# Rezoning Transportation Analysis

Petition Number: 2023-121

## Revision Log:

Date	Description
10-25-23	First Review (JP)

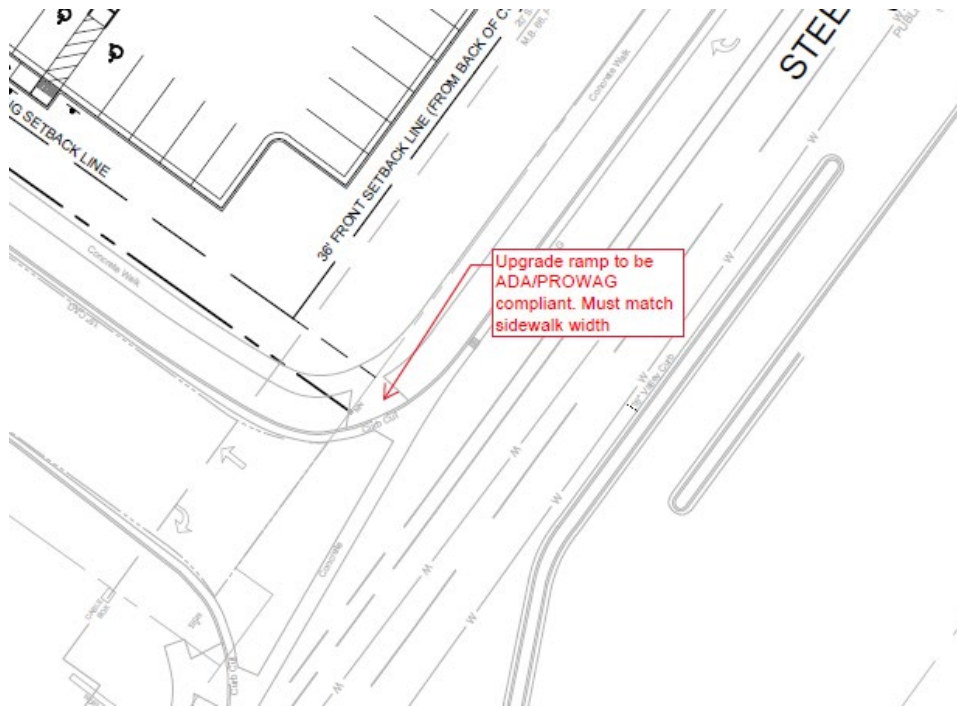
**1. Curblines:**

- a. **Steele Creek Road:** future location of curb and gutter is in its existing location.

Label and dimension the curb and gutter from the centerline for each road on the site plan.

- 3. Revise site plan and conditional note(s) to label and dimension the right-of-way from the road centerline.
- 4. Revise site plan and conditional note(s) to commit to upgrading the existing streetscape to 8-foot sidewalk and 8-foot planting strip across the site's frontage on Steele Creek Road in accordance with the UDO section 32.7(D)(2)(a)(iv).
